CERTIFICATE OF APPROPRIATENESS

Property: 715 Henderson Street, Tract 7, Block 407, Baker WR NSBB Subdivision. The property includes a historic one-story wood clad storefront commercial building situated on a 4,000 square foot corner lot.

Proposal: Alteration – Install a new round cabinet sign above the contributing corner store canopy facing Henderson Street. Sign is a back-lit, four foot diameter acrylic and aluminum box with vinyl paint.
See enclosed application materials and detailed project description on p. 4-11 for further details.

SIGN DETAILS - DESIGN

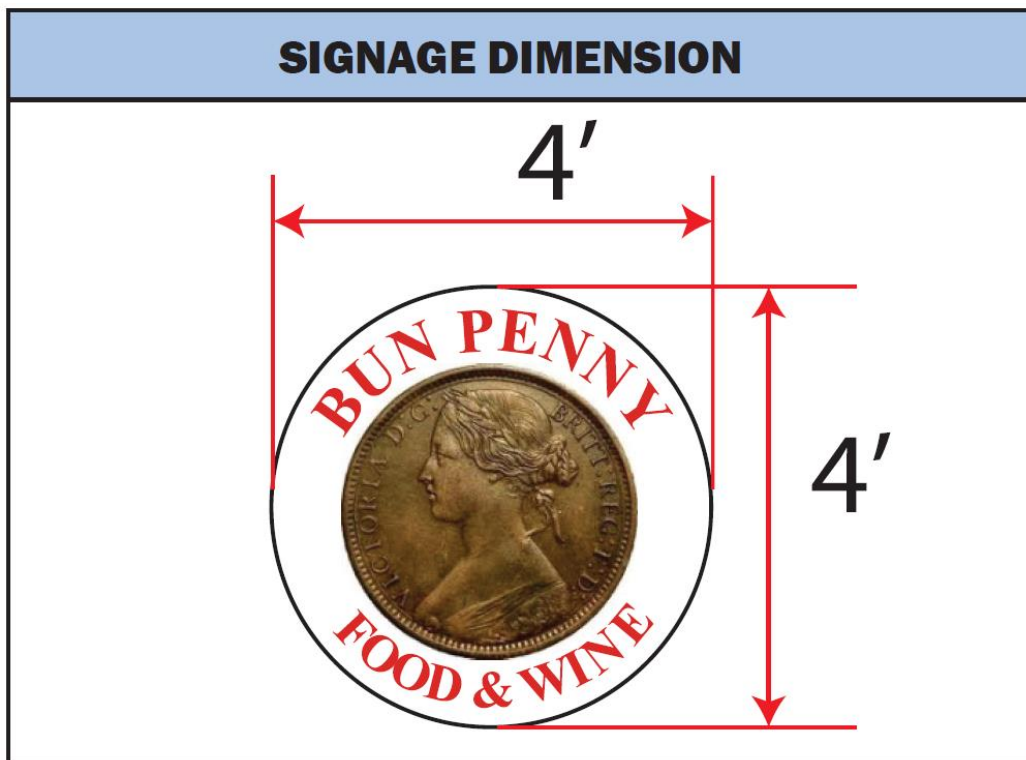
The proposed internally lit acrylic cabinet sign does not comply with Section IV.D.a, Recommendations for Building Signage, of the Old Sixth Ward Protected Historic District Design Guidelines. The Guidelines state that all signage must be illuminated indirectly using an external light source, no backlit or channel cut lighting is permitted, and no plastic letters are permitted. Additionally, the sign must be mounted directly on the wall surface and the background must be the building wall. Although the sign is fastened to the wall, the sign is an independent feature with the words and logo painted onto an acrylic sheet inserted into a light box that extends out 7" and not installed directly onto the building wall.

Section IV.D.b, Recommendations for Sign Bands, states that cabinet signs are not permitted.

ADDITIONAL SIGN DETAILS

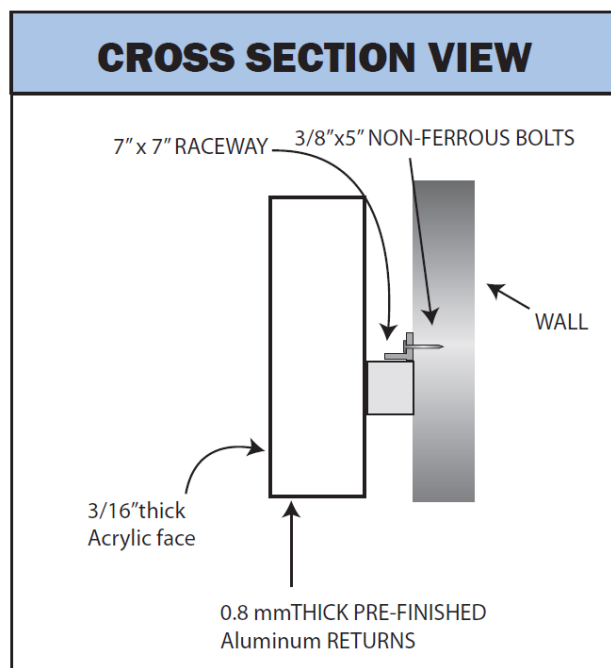
715 Henderson: deny. The sign is plastic and back-lit, both explicitly prohibited for "building signage" in the OSW.
